PROPOSED SUBSURFACE WASTE DISPOSAL SYSTEM DETAIL SHEET

SUBDIVISION: Liberty Meadow

LOT ~~2~~ → 3

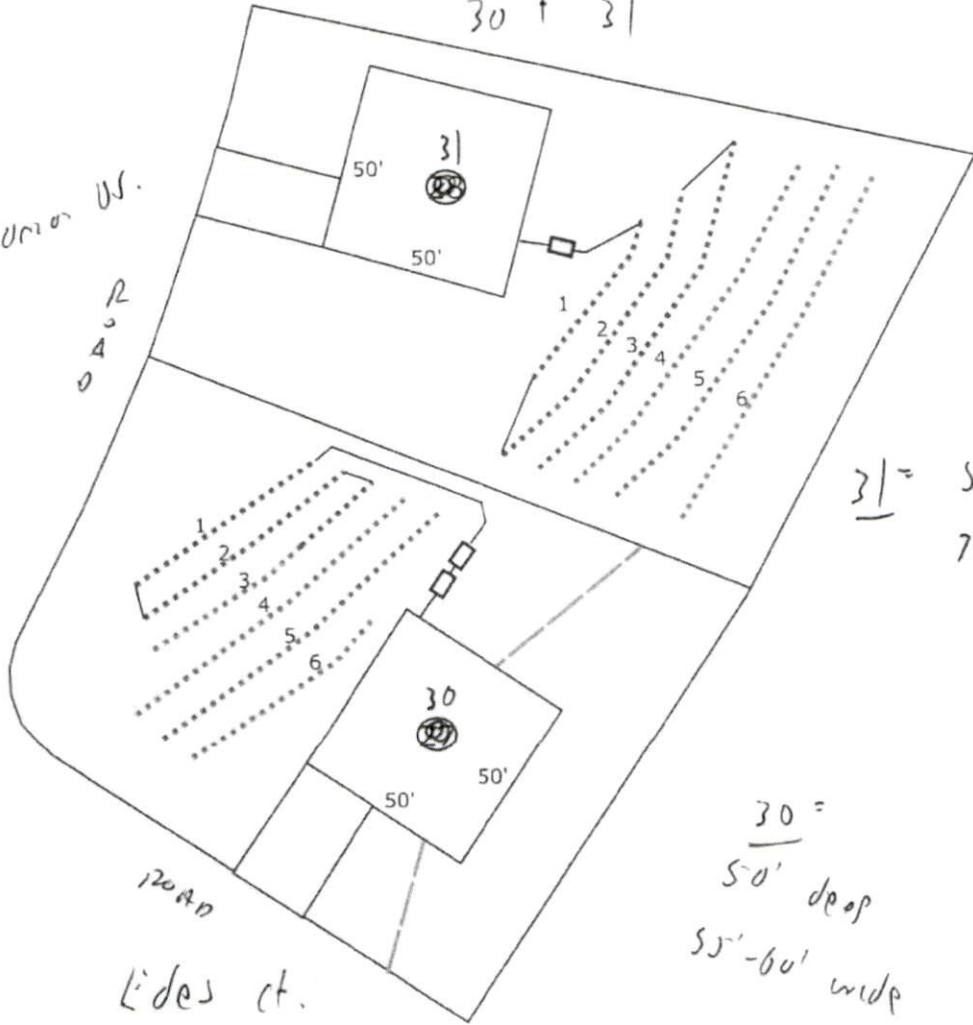
* FD to Remove Path water

* check soils

Lot ~~27~~ & ~~28~~

30 + 31

31 = 50' deep
70' wide

30 =
50' deep
55'-60' wide
